Subject: City of Lake Elmo Landscape Plan Review

Springs at Lake Elmo, Review #1

Project **SPRINGS AT LAKE ELMO**

Sheet Title LANDSCAPE PLAN

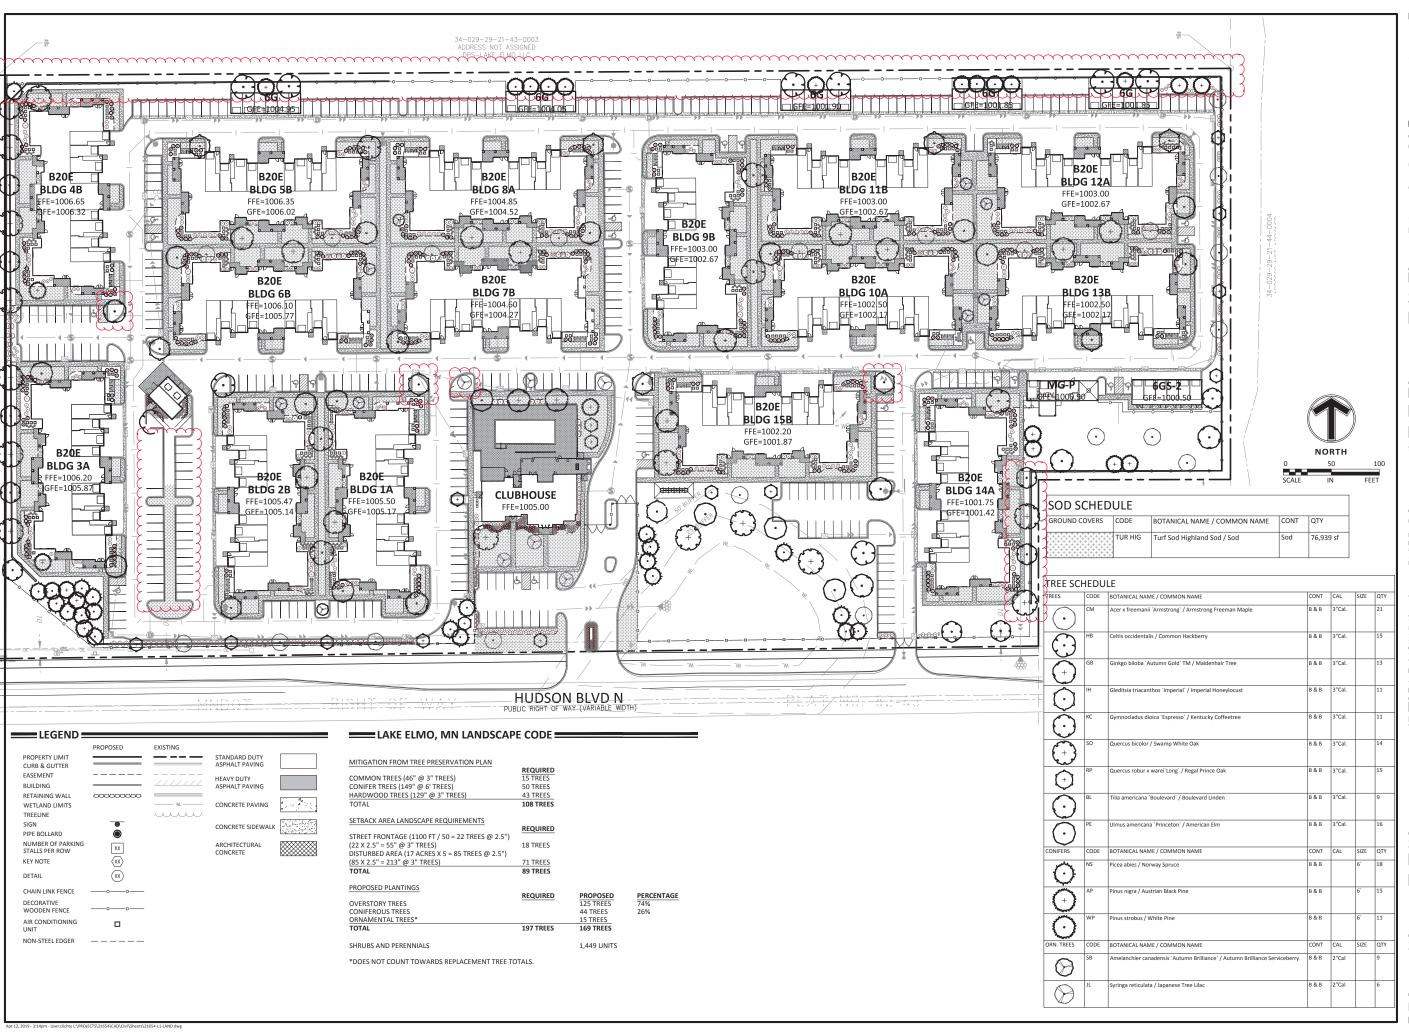
- 3. Preliminary landscape sheets do not include required City standard notes and details. Update details using City standard notes and details.
- 4. There are some landscape conflicts with utility lines. Please refer to attached document for problem areas. Please correct tree spacing so the trunk of trees shall be 10 feet from the nearest utility, including water and sewer service stubs to each lot.

- 5. The preliminary landscape plans do not calculate interior parking lot and perimeter parking lot tree plantings. Please refer to attached document for identified issues. Please update landscape plan to provide the required plantings.

- 6. The north side of the property will need to satisfy both screening and perimeter parking lot requirements.

It is recommended that a condition of approval include submitting a revised landscape plan addressing findings 2-6 listed above.
